UNITED STATES PATENT AND TRADEMARK OFFICE

APPLICATION NO.	FILING DATE	FIRST NAMED INVENTOR	ATTORNEY DOCKET NO.	CONFIRMATION NO.
10/537,372	06/03/2005	Bernard Diem	272637US2PCT	2639

Office Action Summary

DETAILED ACTION

FIG. 13

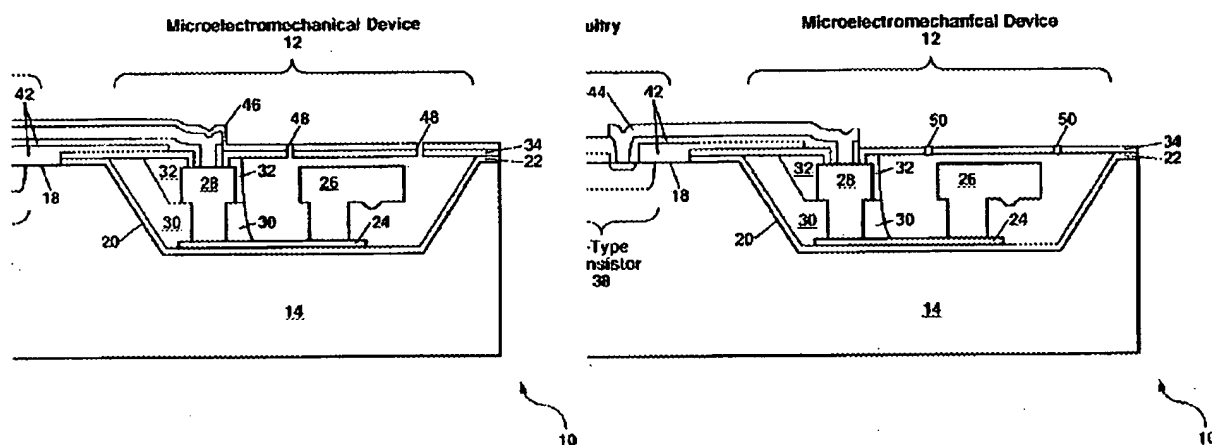
Barron et al '788 discloses a first layer (Fig 13, item 24) insulated from a substrate (Fig 13, item 14) by an insulator layer (Fig 13, item 22) at least one sensitive element (Fig 13, item 26) connected to at least one contact pad (Fig 13, item 28) by an electrical connection (Fig 13, item 24) and protected by a package cap (Fig 13, item 34), wherein the at least one sensitive element (Fig 13, item 26), the electrical connection (Fig 13, item 24), and the at least one contact pad (Fig 13, item 28) form an assembly (Fig 13, item 12) delimited in the first layer (Fig 13, item 14) by at least one trench (Fig 13, item 30), the assembly (Fig 13, item 12) being covered by the package cap (Fig 13,

item 34), wherein the package cap (Fig 13, item 34) comprises at least one opening (Fig 13, item 44) above the at least one contact pad (Fig 13, item 28) and being integral with the at least one contact pad (Fig 13, item 28) on edges of the at least one opening (Fig 13, item 44) and a zone (Fig 13, item 18) located beyond the at least one trench (Fig 13, item 30) in relation to the assembly (Fig 13, item 12).

Barron et al '788 does not disclose in a first layer at least one sensitive element connected to at least one contact pad by an electrical connection, wherein the at least one sensitive element, the electrical connection, and the at least one contact pad form an assembly delimited in the first layer by at least one trench.

Barron et al '788 discloses the package cap (Fig 13, item 34) is sealed in a leak tight manner to define a leak tight cavity (Col 10, lines 45-47) in which the at least one sensitive element (Fig 13, item 26) is located.

Barron et al '788 discloses the package cap (Fig 13, item 34) further comprises at least one orifice (Fig 12, item 48) configured to be being sealed by a plug (Fig 13, item 50) to control atmosphere of the cavity (Col 10, lines 45-47).

Barron et al '788 discloses the electrical connection (Fig 13, item 24), the at least one contact pad (Fig 13, item 28), and the at least one sensitive element (Fig 13, item 26) are formed in a same material (Col 6, lines 41-50).

Barron et al '788 discloses the package cap (Fig 13, item 34) is formed in a dielectric material (Col 7, lines 54-55).

Barron et al '788 discloses the at least one contact pad (Fig 13, item 28) is covered with a conductive band (Fig 13, item 44) at a level of the at least one opening (Fig 13, item 44).

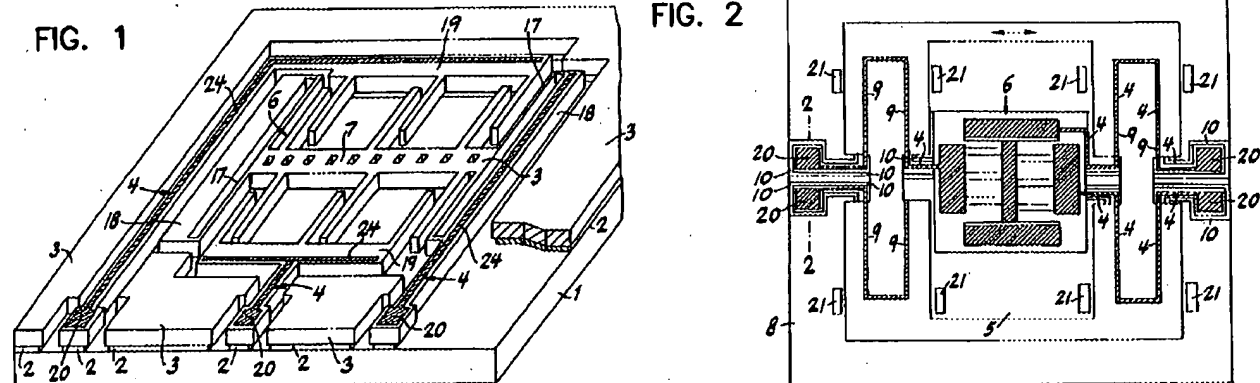
However, Muenzel et al '353 discloses in a first layer (Col 3-4) at least one sensitive element (Fig 1, item 7) connected to at least one contact pad (Fig 1, item 20) by an electrical connection (Fig 1, item 4). wherein the at least one sensitive element

(Fig 1, item 7), the electrical connection (Fig 1, item 4), and the at least one contact pad (Fig 1, item 20) form an assembly (Fig 1) delimited in the first layer (Fig 13, item 3) by at least one trench (Fig 2, item 10)

FIG. 4m

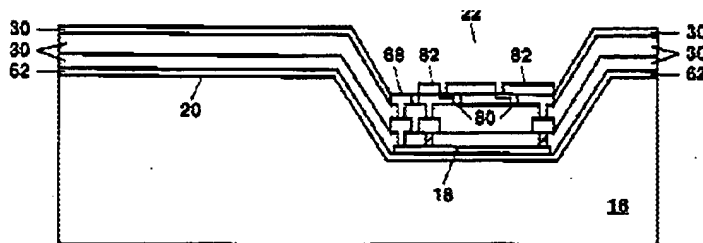
However, Eaton et al '336 discloses the package cap (Fig 4m, item 82) is formed in a semi-conductor or conductor material (Col 14, lines 1-4).

FIG. 4p

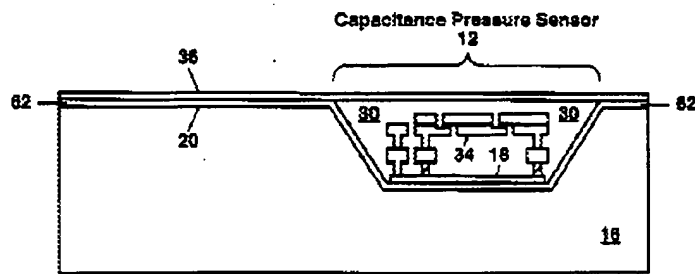
However, Eaton et al '336 discloses the assembly (Fig 4p, item 12) and the package cap (Fig 4m, item 82) are formed in a same conductor or semi-conductor material (Col 13, lines 5-29; Col 14, lines 1-4).

FIG. 4r

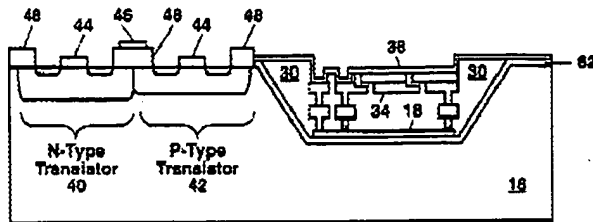
However, Eaton et al '336 discloses a dielectric layer (Fig 4r, item 38) insulates the package cap (Fig 4m, item 82) from the at least one contact pad (Fig 4m, item 68).

However, Eaton et al '336 discloses a dielectric layer (Fig 4r, item 38) insulates the package cap (Fig 4r, item 82) from the zone (fig 4r, item 48).

FIG. 4l

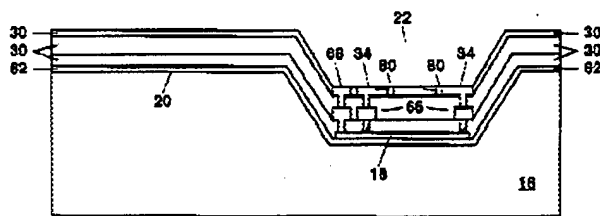
However, Eaton et al '336 discloses the package cap (Fig 4m, item 82) further comprises at least one pillar (Fig 4l, item 66) resting on a zone of the at least one sensitive element (Fig 4l, item 18).

FIG. 4e

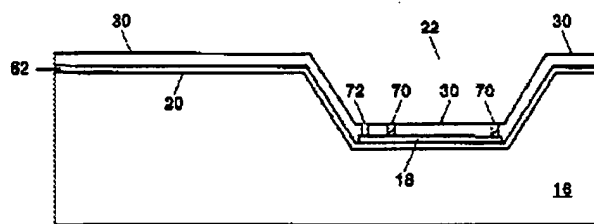
However, Eaton et al '336 discloses the zone of the at least one sensitive element (Fig 4e, item 18) is integral (Fig 4e, item 62) with the substrate (Fig 4e, item 16).

However, Eaton et al '336 discloses the package cap (Fig 4m, item 82) is formed in a conductor or semi-conductor material (Col 14, lines 1-4), and comprises at least one pillar (Fig 4l, item 66) resting on a zone of the at least one sensitive element (Fig 4e, item 18), the package cap (Fig 4m, item 82) and the at least one pillar (Fig 4l, item 66) contributing to forming an electrical connection (Col 17, lines 2-4) with the zone (Fig 4e, item 18).

However, Eaton et al '336 discloses wherein the package cap (Fig 4m, item 82) is formed in a conductor or semi-conductor material (Col 14, lines 1-4), and the at least one pillar (Fig 4l, item 66) is electrically insulated (Fig 4e, item 70) from the at least one sensitive element (Fig 4e, item 18)
